469-483 Balmain Road, Lilyfield

Submission to PP_2017_IWEST_018_00

RE: 469 – 483 BALMAIN ROAD, LILYFIELD – PLANNING PROPOSAL

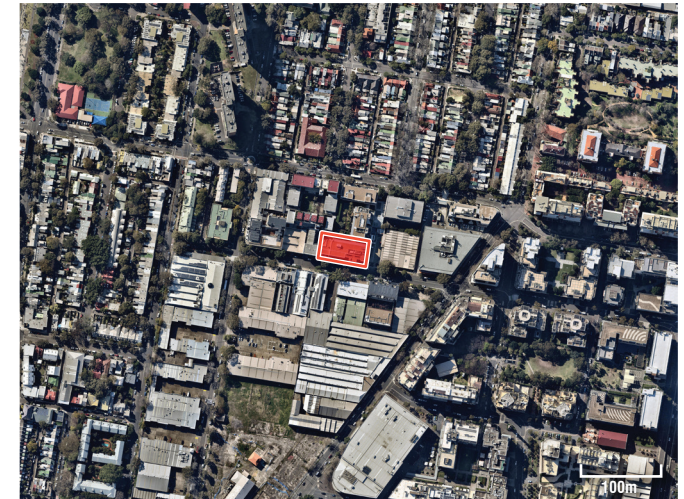
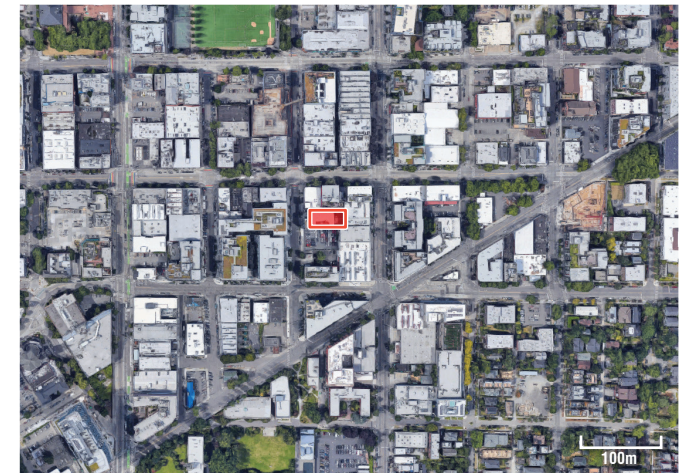
The urban design report provides a number of case study precedents located within Australia and overseas. Yet there is no justification as to why these precedent examples have been selected by Roberts Day.

Our review indicates there may be some relevance regarding the types and mix of building uses. However, there is no justification in support of the scale of the proposed built form.

As demonstrated by the aerals to the right (**Figures 2-5**), the examples selected are located in medium to high density areas which are appropriate locations for large built forms, not low density areas such as Lilyfield (**Figure 6**).

Figure 9: Proposed Urban Block Concept (adapted from Roberts Day UDR) pg.66)

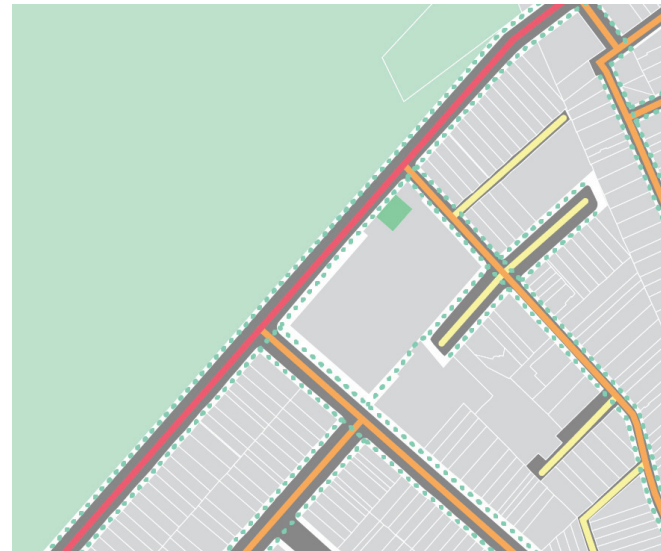
The proposed scheme only improves the permeability of the site by:

- widening the existing footpaths; and
- providing a pedestrian link between Fred Street and Alberto Street.

Figure 10: Preferred Urban Block Outcome

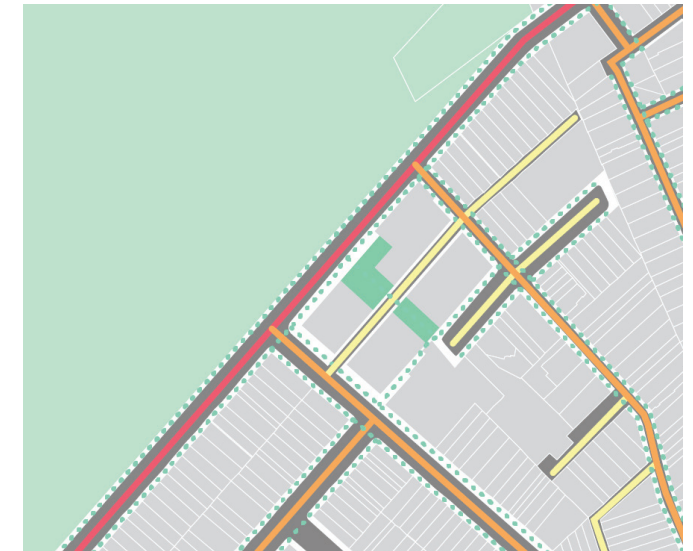
- continuing Fred Lane through to Alberto Street;
- providing a pedestrian link from Balmain Road to Fred Street.

This would result in four potential parcels which could be developed upon.

Figure 13: Preferred Built Form Outcome

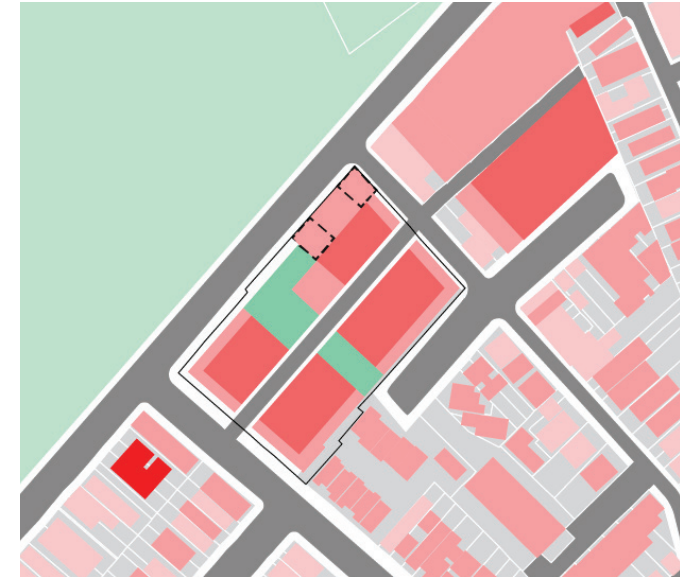
- provides an overall building height consistent with other buildings in the vicinity of the site;
- presents a two storey street wall height which is compatible with the existing streetscape;
- provides significant setbacks for the third storey ensuring it is not visible from the pedestrian perspective;
- provides open space along the ground plane ensuring it is easily accessible and of high amenity;
- improves the vehicular and pedestrian permeability of the locality; and
- retains the existing character buildings of the site.

The preferred outcome shown in **Figure 13** presents a two storey streetwall along Balmain Road with a third storey well setback from the street. This presents a much better built form outcome which is compatible with the existing streetscape and local character.

Figure 18: Proposed Alberto Street Streetscape

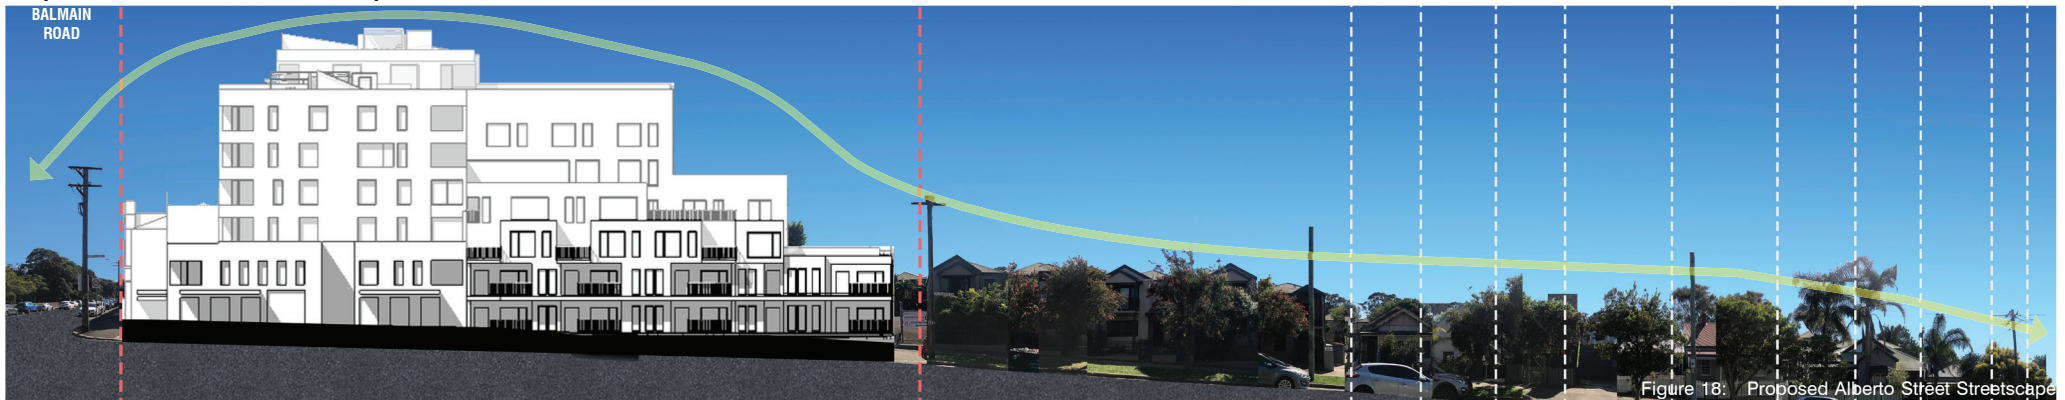
While the proposed two storey street wall height is supported, the upper levels will be visible from the pedestrian perspective presenting a built form that is completely out of character with the existing streetscape.

Figure 23: Preferred open space location

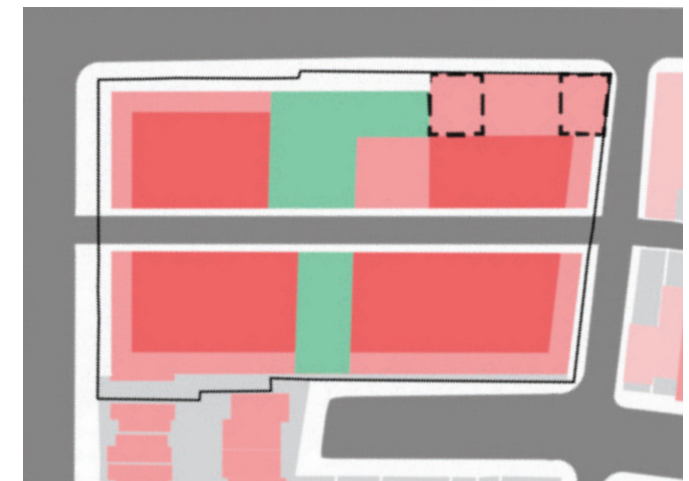
Given the sites large area, open space should be provided along the ground plane consequentially creating a through site link and separating built forms as demonstrated in **Figure 23**.

Figure 24: Solar analysis diagrams (source: Roberts Day UDR pg.79 & 79)

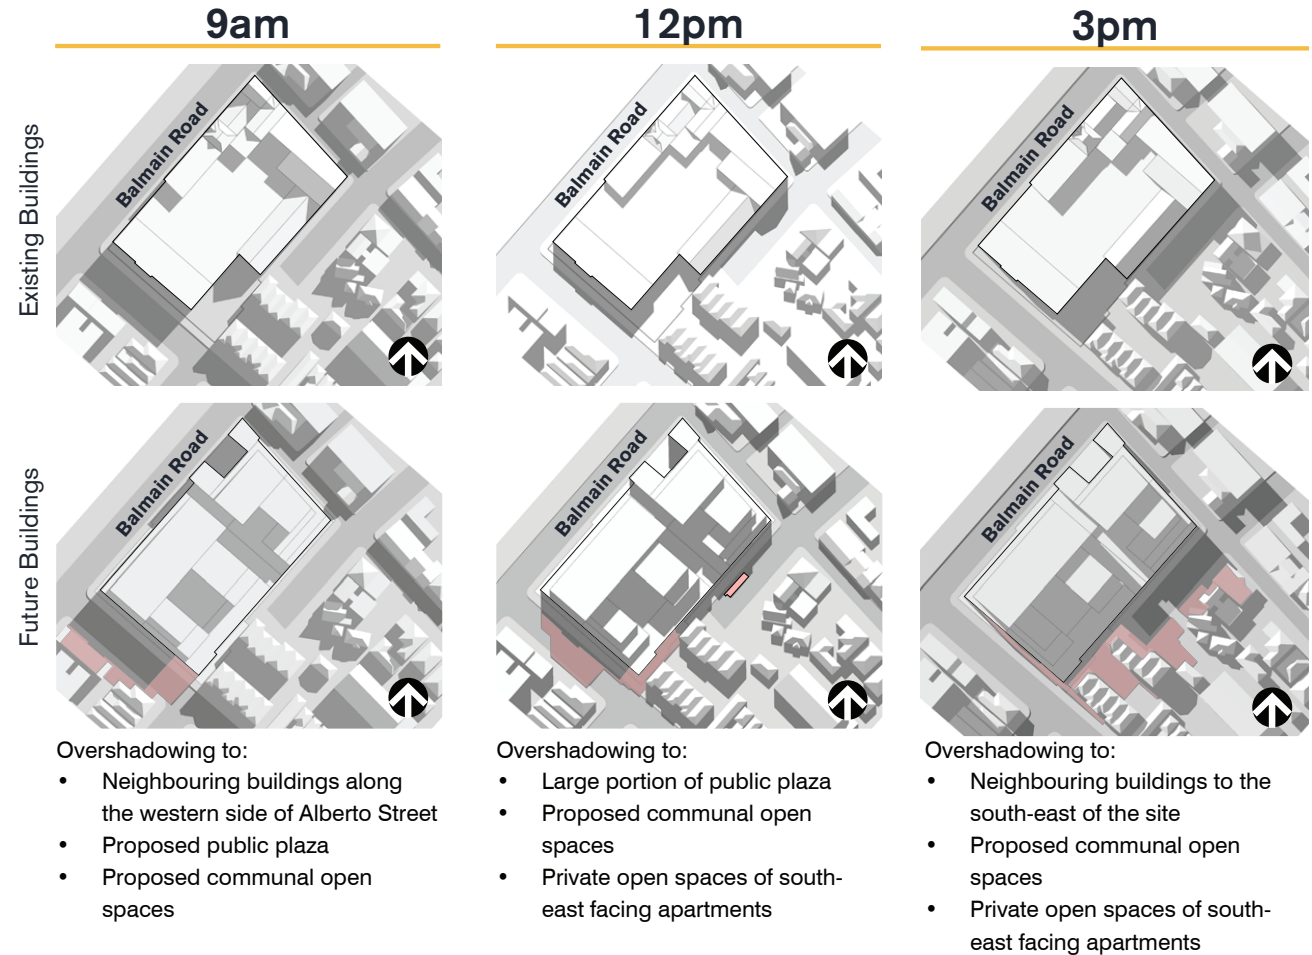
Solar analysis diagrams presented in the report indicate the proposal will have poor solar amenity and impact the existing amenity of neighbouring residential properties.

- The proposal will create significant overshadowing impacts to neighbouring properties along Alberto Street and Fred Street.
- The communal open space areas within the site will be of extremely poor amenity as they will receive no direct sunlight at any time throughout the day.
- The private open space of apartments overlooking Fred Street will be in shadow from 10am onwards.

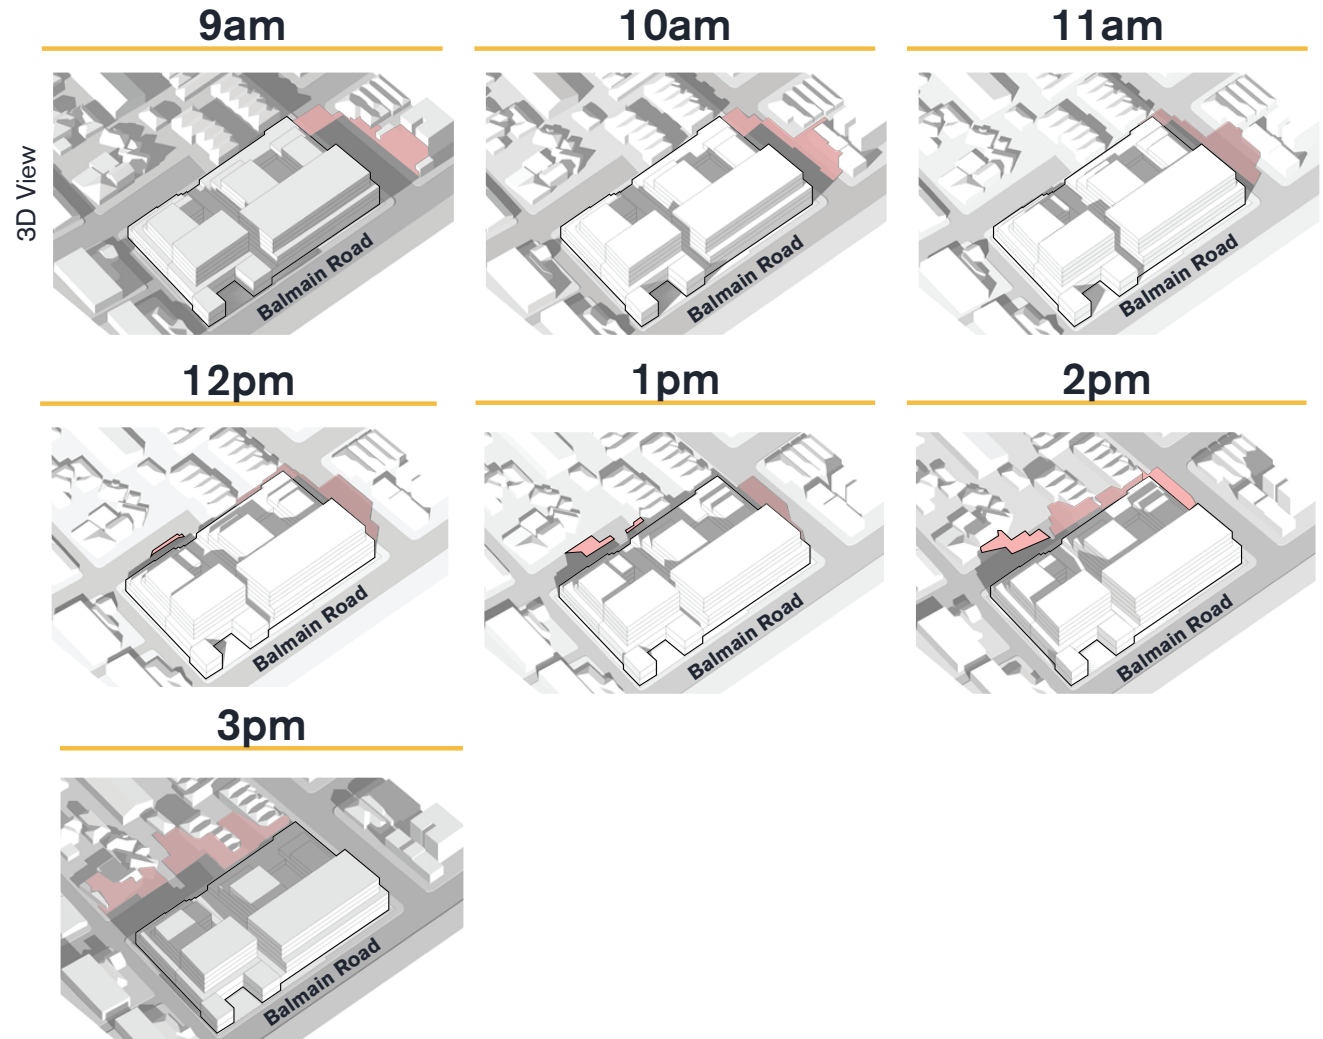
The solar access/shadow diagrams presented in the report are inadequate and do not properly demonstrate overshadowing to the site's surrounds or solar access to the proposed residential apartments and communal areas.

Views from the sun diagrams should be produced to better understand the shadow impacts of the proposal.

Figure 25: Proposed LEP height control (source: Roberts Day UDR pg.85)

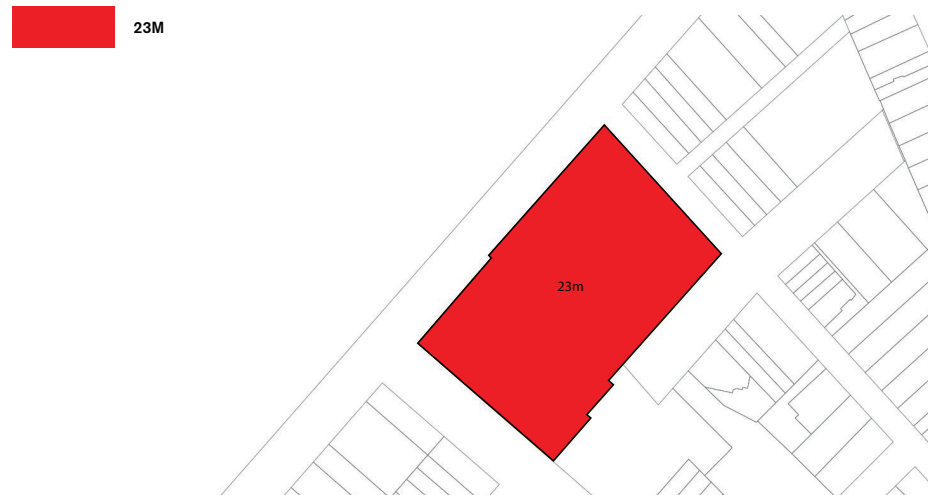
The proposed controls do not provide enough restriction to ensure that future development is not of a larger scale than the proposed massing illustrated in the report.

The proposed maximum building height across the site is 23 metres and the built form controls in the proposed Development Control Plan only propose 3m upper level setbacks and a 9.55m streetwall height along Fred Street.

The lack of restriction proposed in these controls creates the potential for a building typology that is very different to the illustrated massing shown throughout the report.

Figure 1

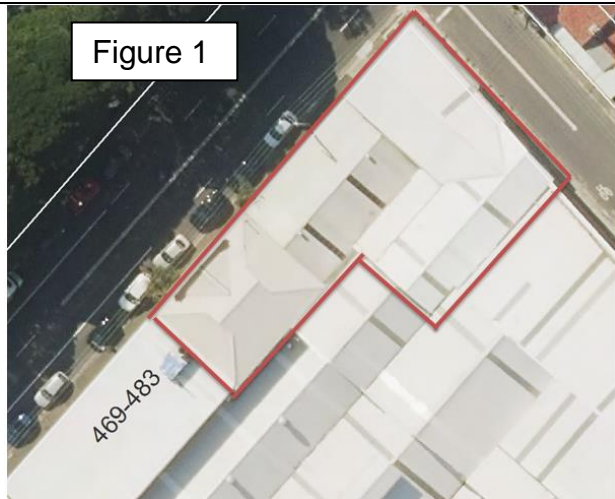
The ABBCO office building, Pilchers Bakery (2 storey brick building on the corner of Balmain Road and Cecily Street) and the connecting building between these two fronting Balmain Road (refer to Figure 1) are therefore worthy of heritage listing under Leichhardt LEP given their significant fabric and must be protected. The proposed concept design currently shows that a significant part of the Pilchers Bakery building would be demolished and must be amended to show its protection and retention. Council's Heritage Advisor site inspection established that the structural walls, floors and ceilings appear intact. The internal partitions and alterations such as false ceilings are reversible and the original floor plan is recoverable. The condition of these buildings do not warrant demolition.

This will underpin a revision of the Planning Proposal to propose the heritage listing of the ABBCO, Pilchers Bakery and connecting buildings shown in Figure 1.
